Custom Bottle Inc.
10 Great Hill Road
P.O. Box 720
Naugatuck, Connecticut 06770
203-723-6681

DRAWN BY: 001	DESC.: 32oz. CLASSIC CYL.
SCALE: 1-1 DATE: 18/10/95	DRAWING NO.: 107-2787-PA
BOTTLE MAT'L: HDPE	1
CAD NAME: PD\	C.B.I.D.: #134

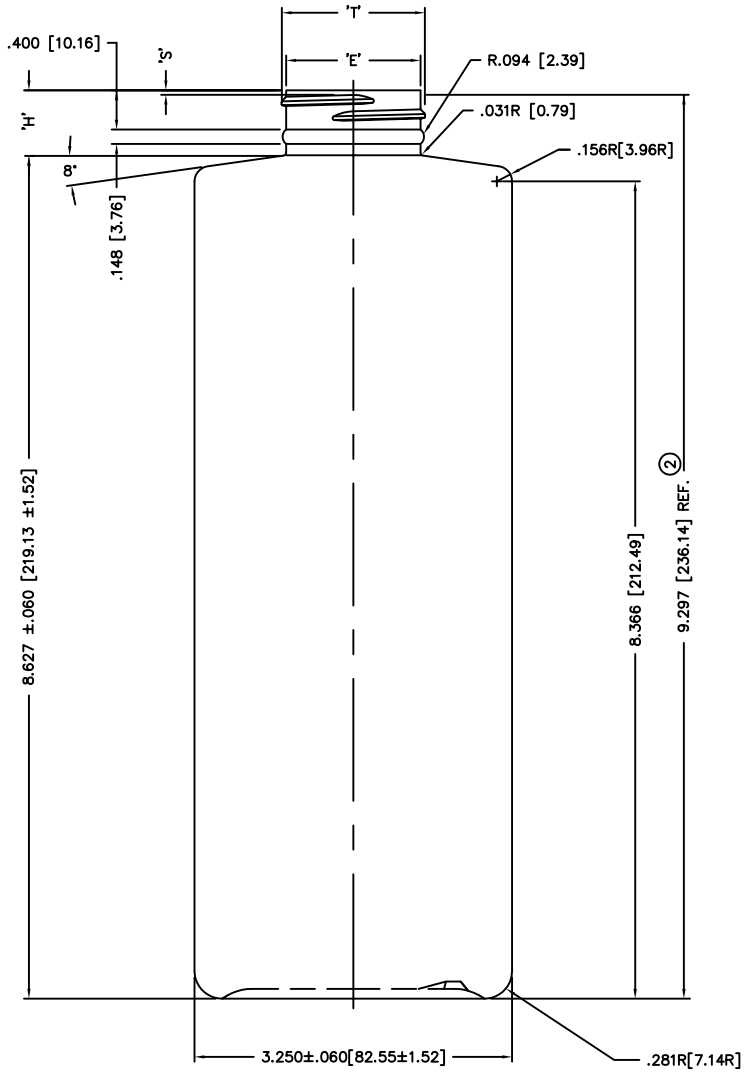
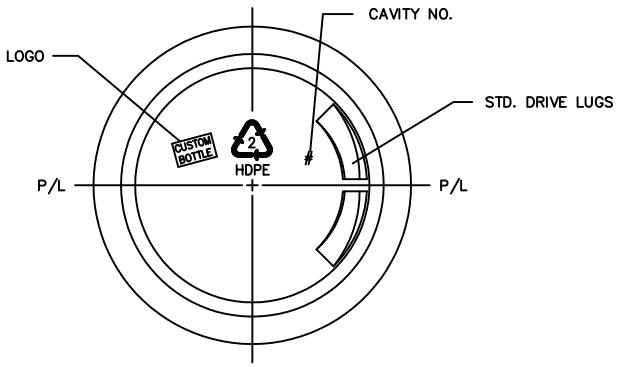
NO.	REV.BY	DESCRIPTION	DATE
②		HEIGHT 9.297 [236.14] REF WAS 9.052 [229.92] REF.	1/11/95
①		'H' .670±.015 [11.94±0.38] WAS .425±.015 [10.80±0.38]	" "
